MADISON PARK MULTIFAMILY

MASTER USE PERMIT
DESIGN RECOMMENDATION PACKAGE -
ADMINISTRATIVE DESIGN REVIEW

SEATTLE DCI PROJECT #: 3038537-LU (3024825-EG)
06/30/22

EDG ITEMIZED RESPONSE

Street Access Proposed Driveway

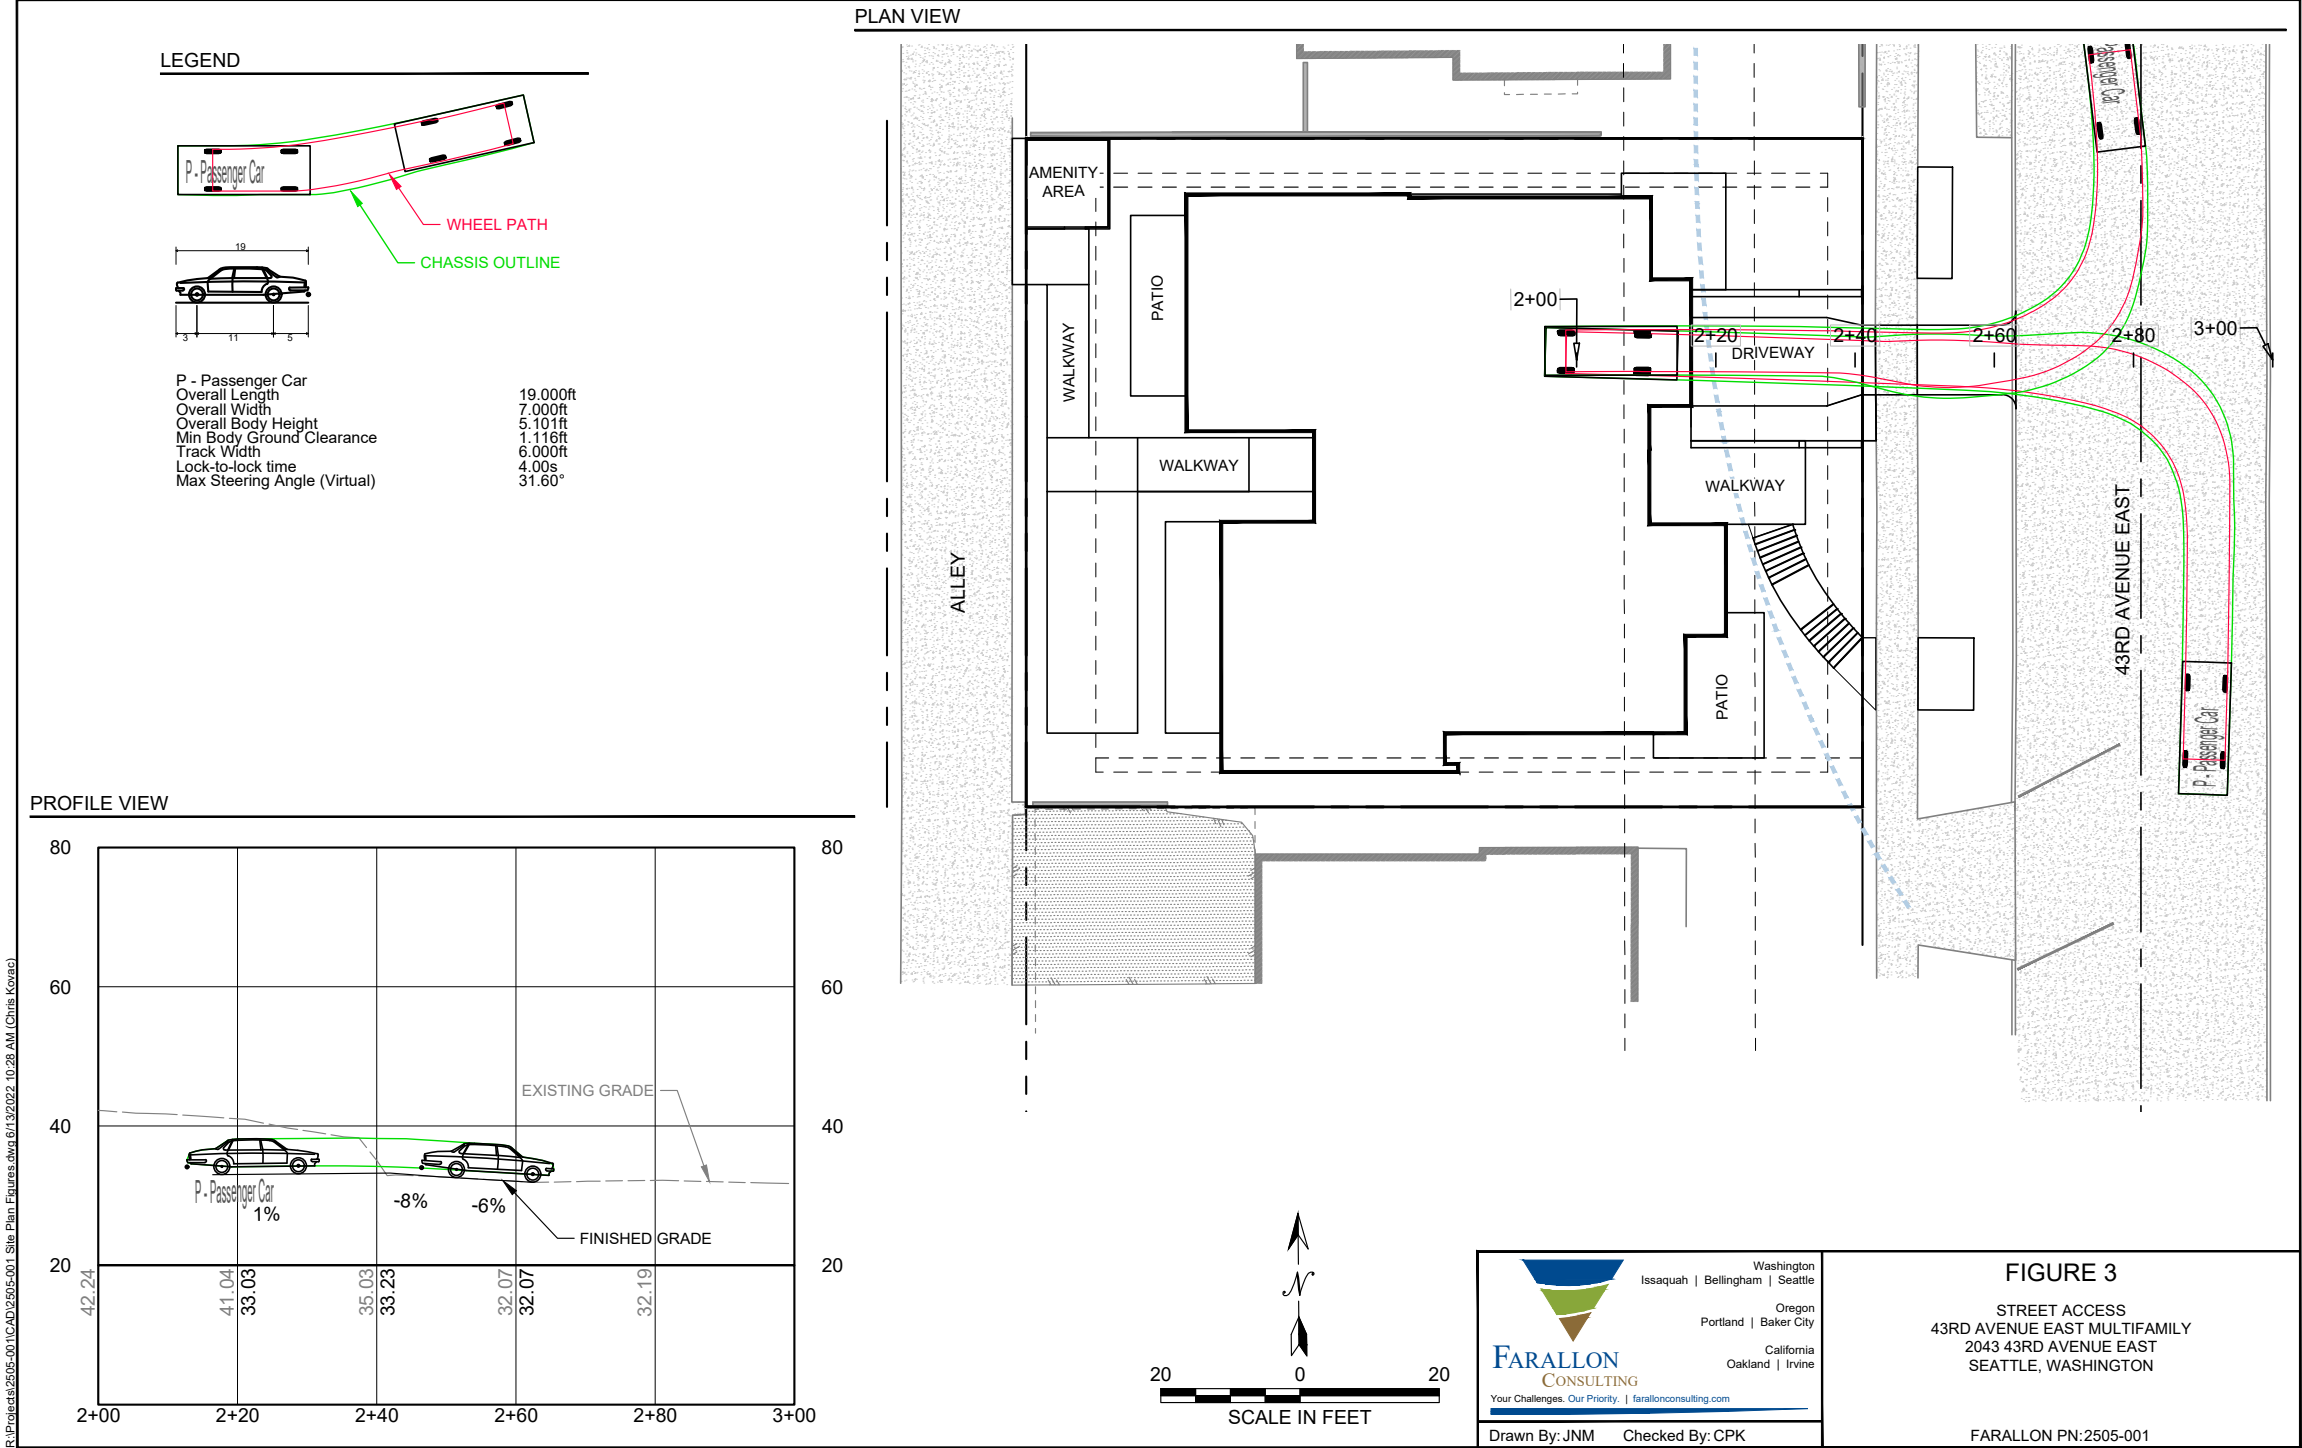
C. In agreement with the Board at the First EDG meeting, Staff requests that the design team provide additional documentation showing how a parking ramp with a slope of 20% may or may not work in contrast to the 15% ramp presented in the EDG packet. (PL4-A-1, PL4-B-2, PL4-B-2, PL4-B-3)

Our engineer's recommendation is to provide access from the street as staff supported Alternative A proposes, with an approximate slope of less than 8%. Refer to engineer's driveway access plan on page 31.

Rendered Image of Signage

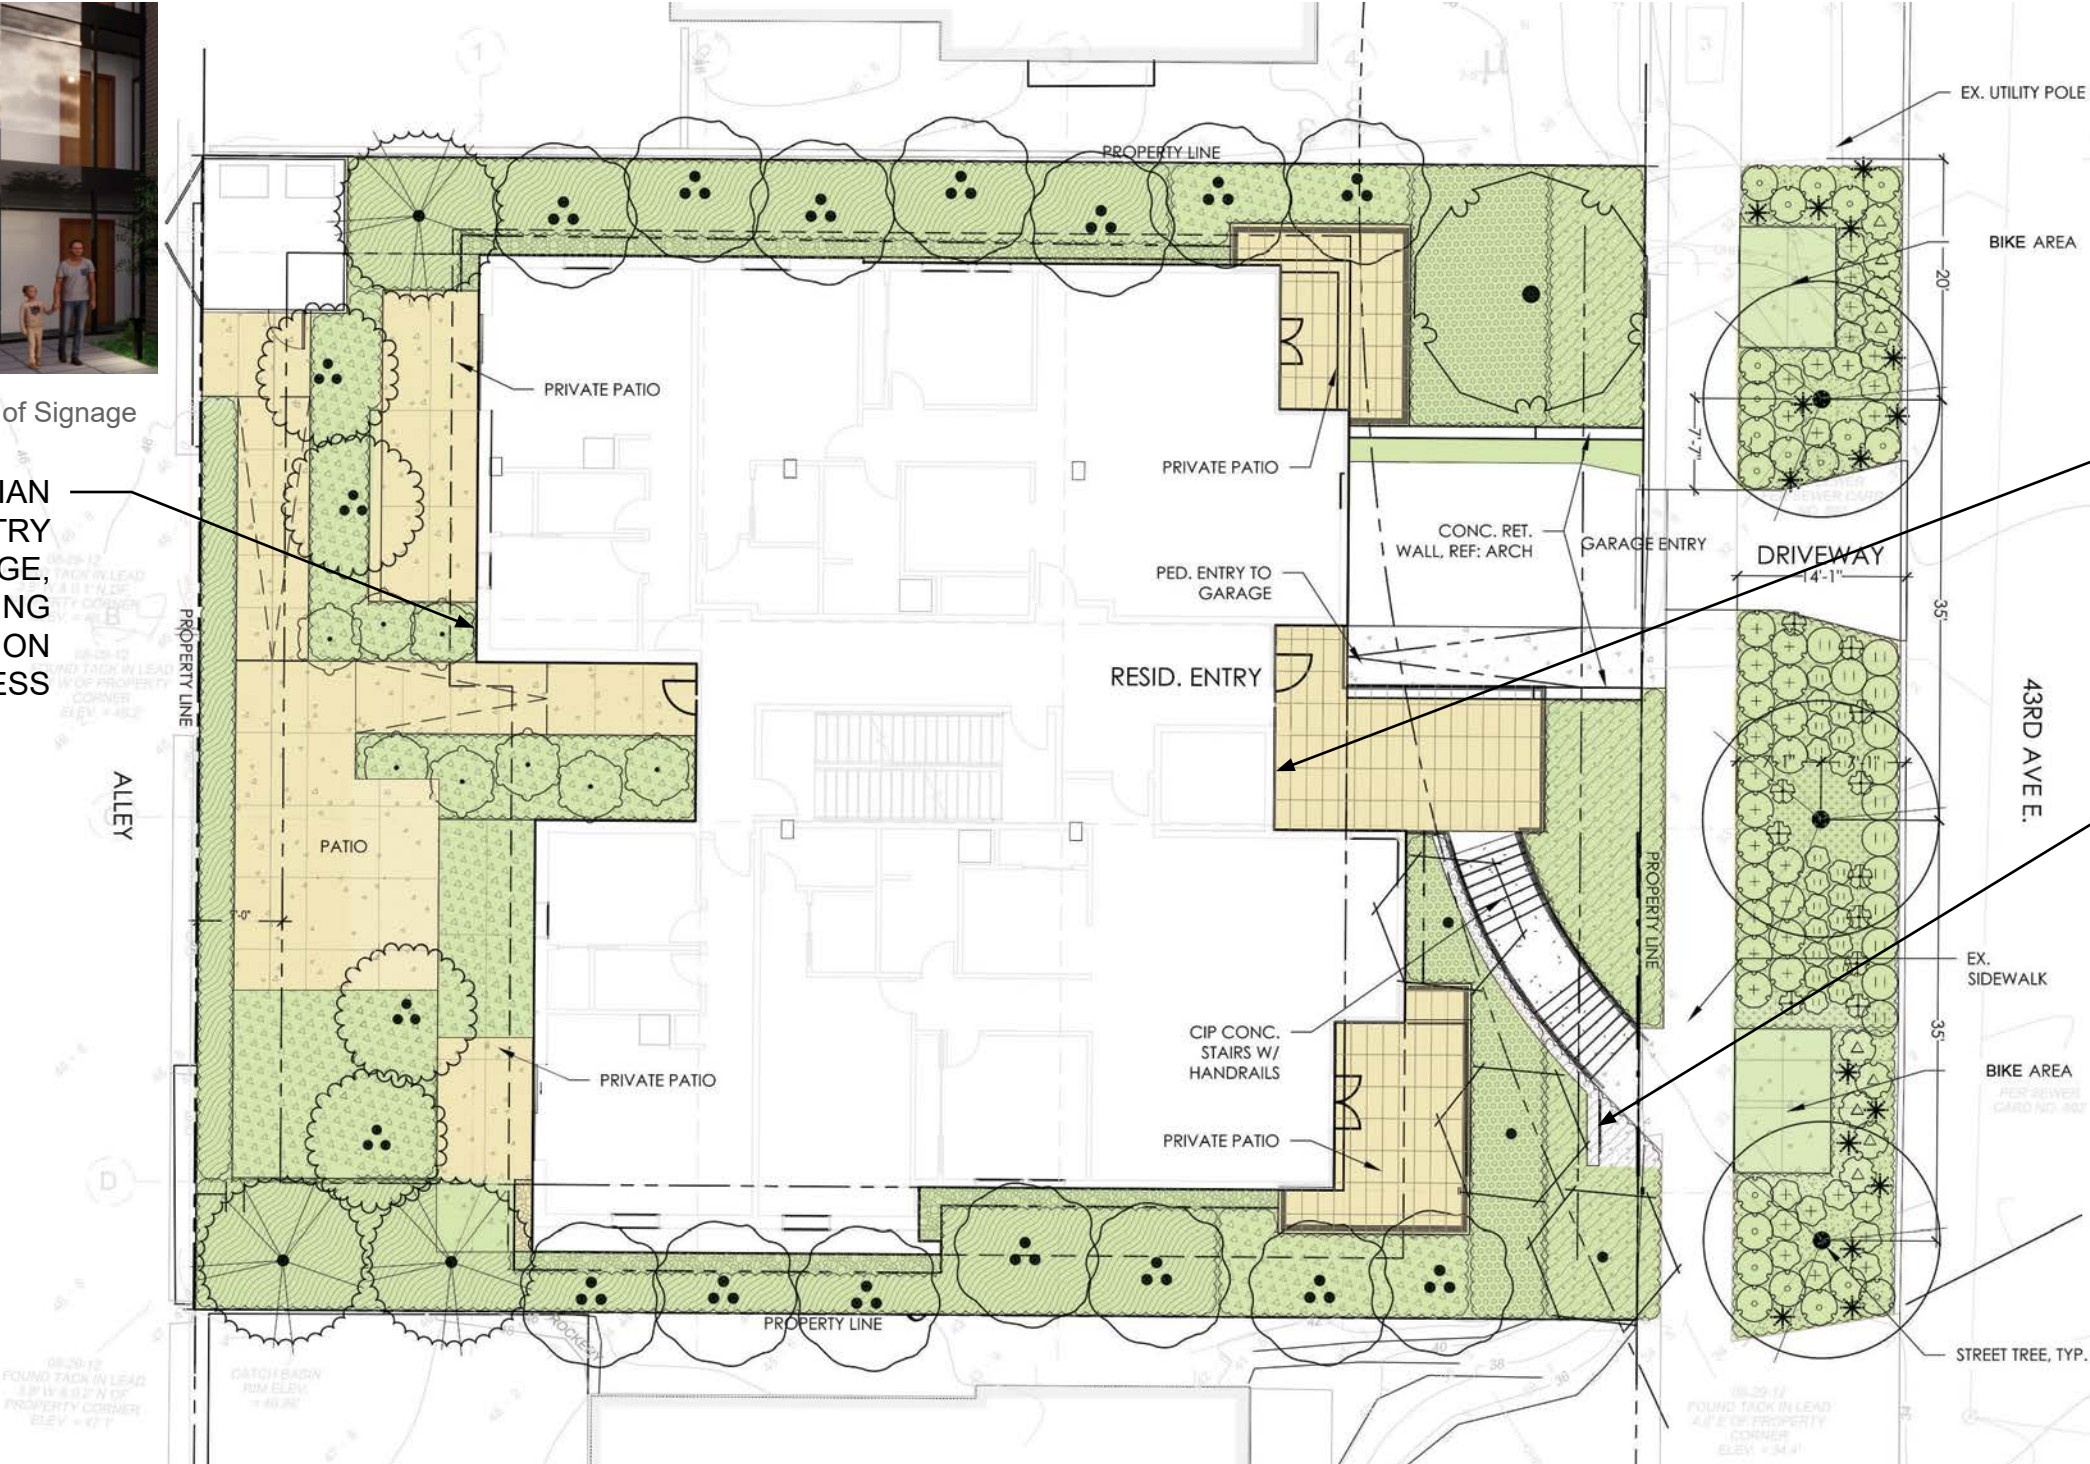
B. Signage will be critical for wayfinding purposes especially as it relates to the pedestrian entry. Design signage to add interest to the streetscape, relate to the design concept, and convey pedestrian access into the site. The applicant team should provide a conceptual signage plan for the next stage of the review. (PL2-D, DC4-B, DC4-D)

We have provided a widened landing to the curved retaining wall of the entry stair to allow for a sizeable location for mounting building identification signage as well as provide an area for added seating. This extension along the sidewalk is the visual cue to the public realm of the building entry point. Identifying signage will also be located at both the main and secondary entry near the door. This will allow for easy identification from pedestrian and vehicular traffic. Refer to page 33 for a signage plan, 3D imagery and examples of proposed signage.

Access Path for Trash/Recycle Storage

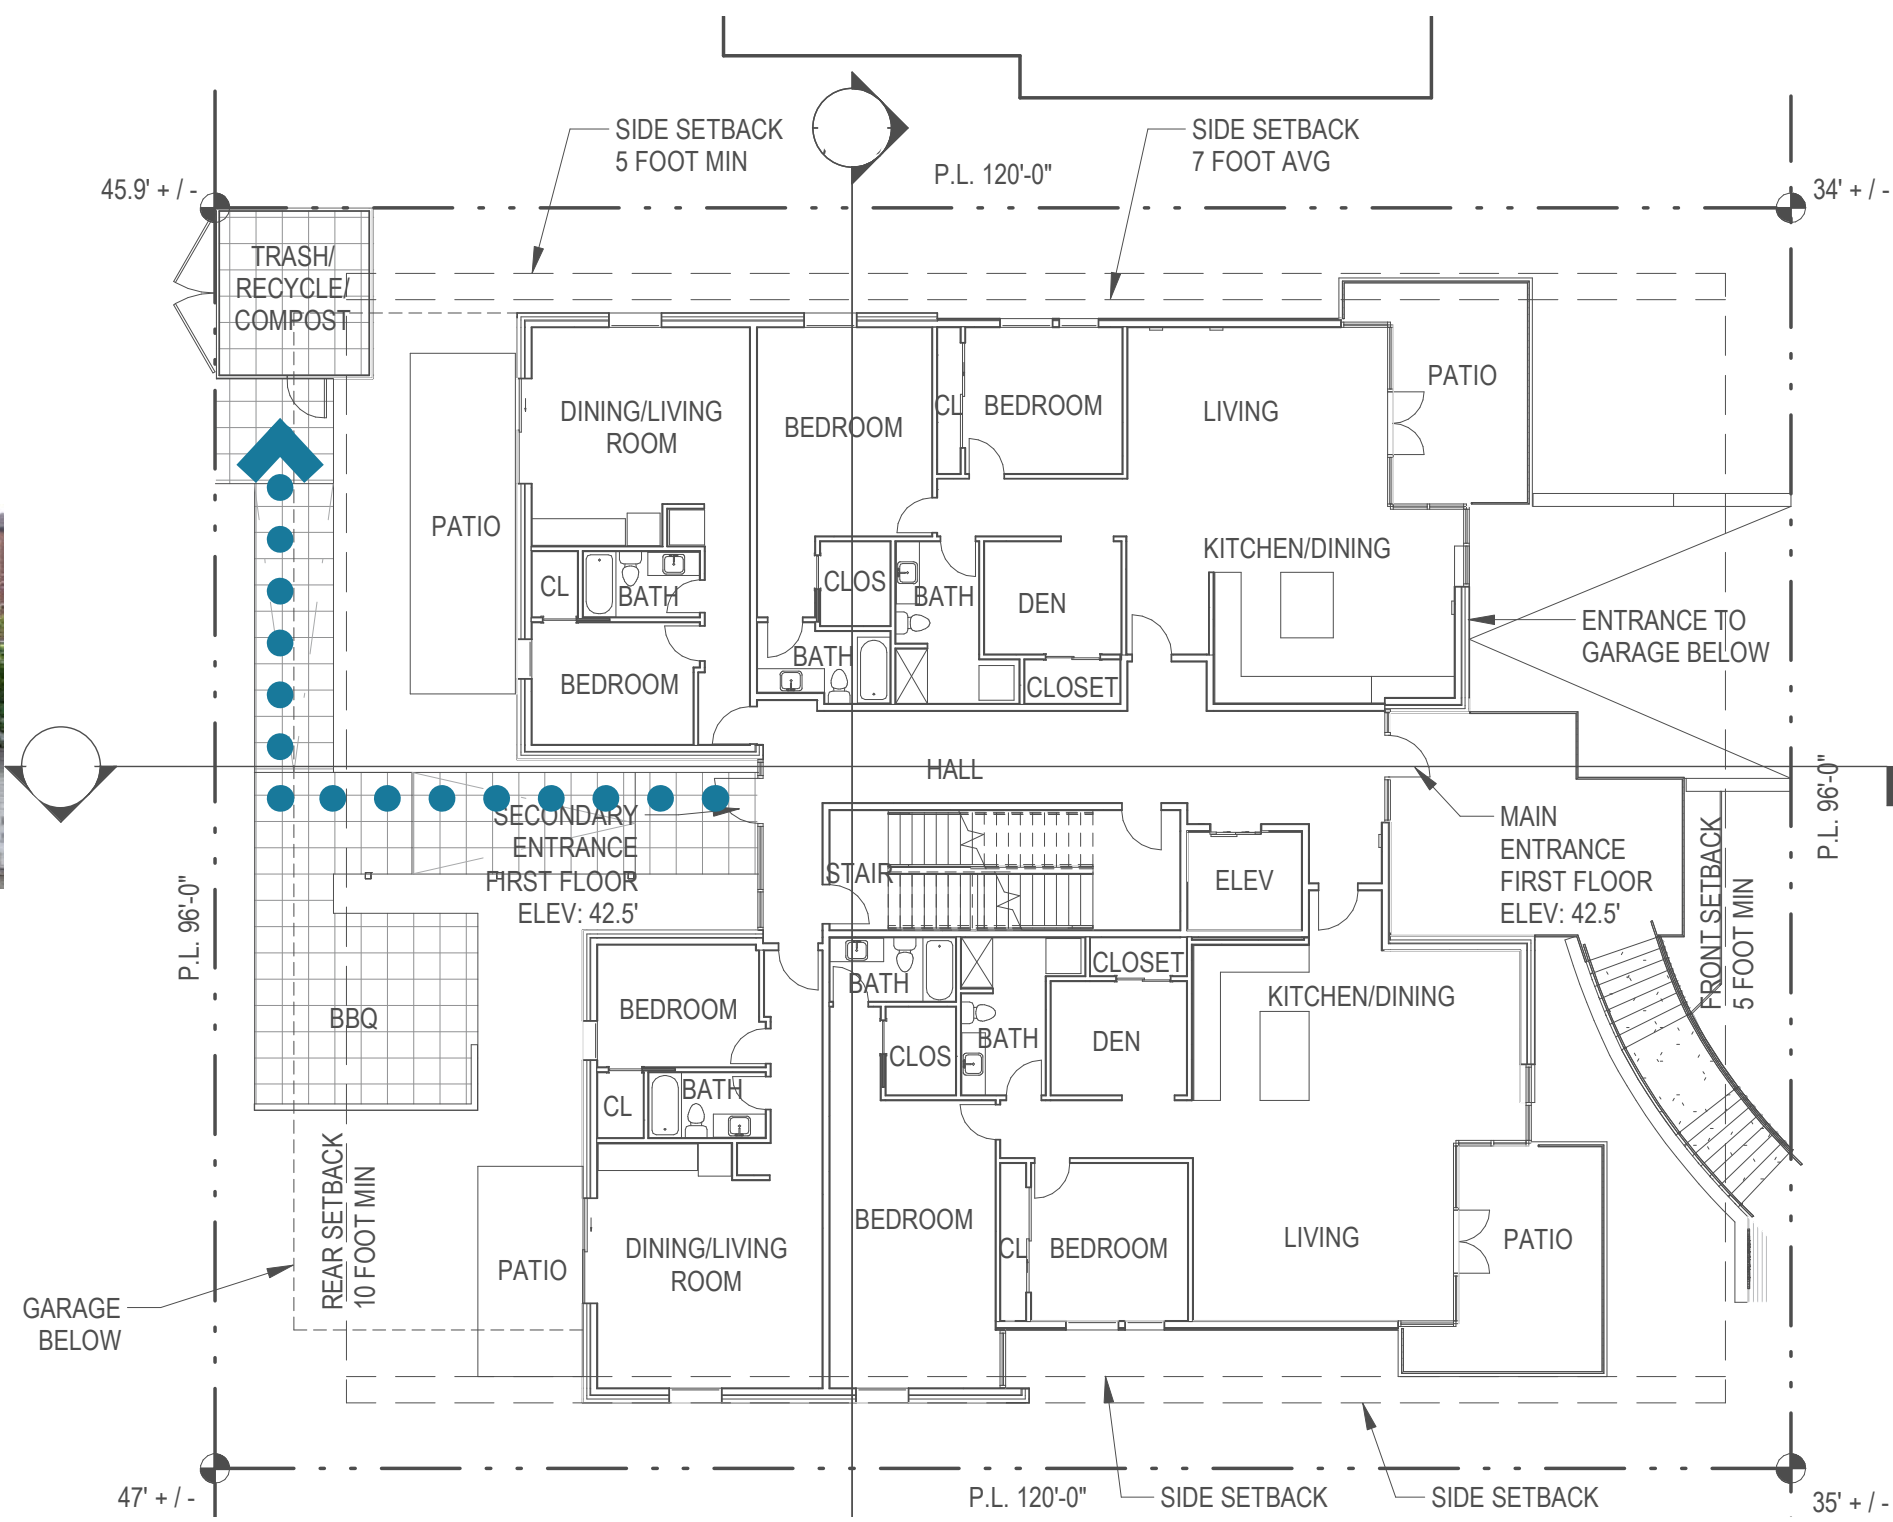
A. The design team shall provide additional details demonstrating how trash/recycling is accessed from the interior of the building and how the trash area relates to individual units. (DC2-B-1, DC1-C-4)

The trash enclosure is accessed from the secondary entrance for all units, off the alley. The path leads directly to the trash/recycling area. The waste/utility company was contacted, and determined that the pickup is off the alley, therefore most convenient to locate the trash/recycle collection location on the alley side of the building. Residents will be required to take trash/recycle to the designated enclosure see in the diagram on page 39.

NORTH/SOUTH SECTION

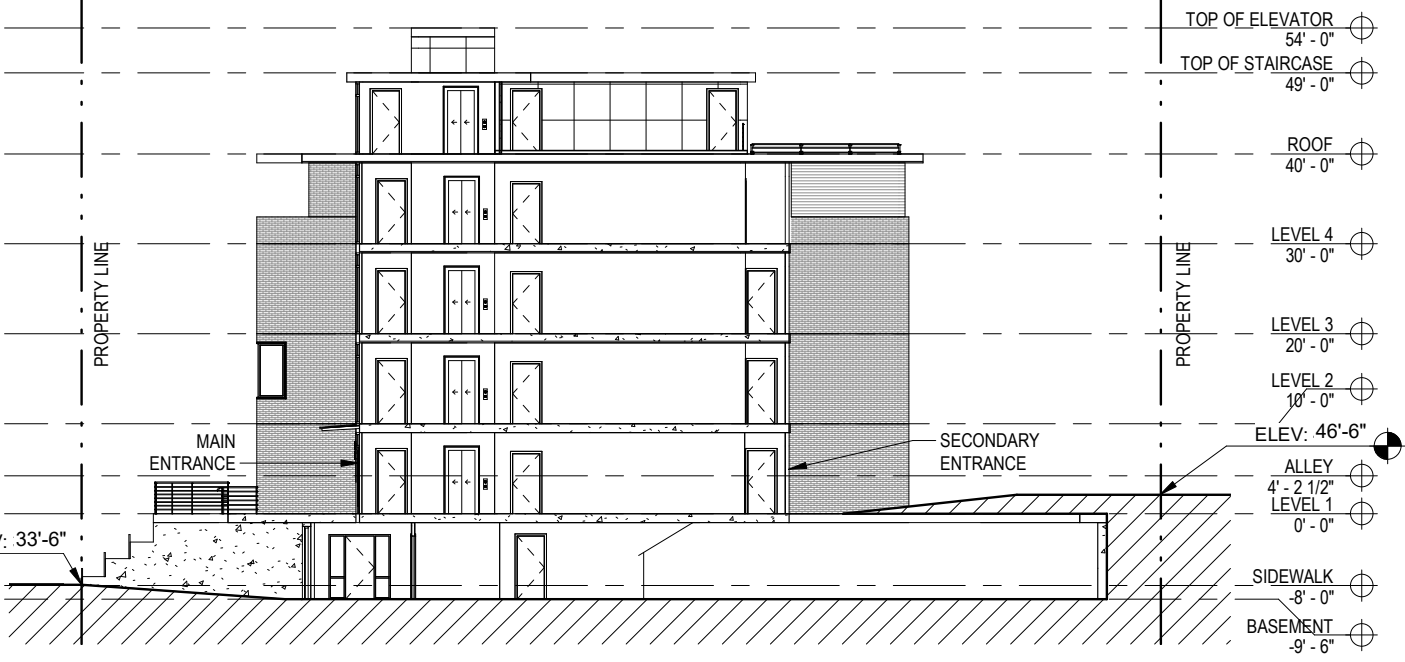
D. Staff requests additional elevation and section drawings that better demonstrates the relationship of the lobby entry, the elevation change and the street edge. (CS21, CS2-D, DC2-A-1, DC2-A-2, DC2-D, DC2-E)

Updated elevation and section drawings have been added that better demonstrates the relationship of the lobby entry, the elevation change, the street edge, and the parking entrance. From the public realm, the pedestrian entry pushes into the property with an inviting landing space with seating provided. The parking level entry is an accessible and intimate entry, recessed from the street edge and allowing for landscape screening and a green wall to create a softer edge at this level. The curving stair entry leading up the the semi-public terrace space directly off the main entry creates movement through the site, vista opportunities to the west, and amenity area for residents and visitors to interact. Refer to page 51-53 for more information.
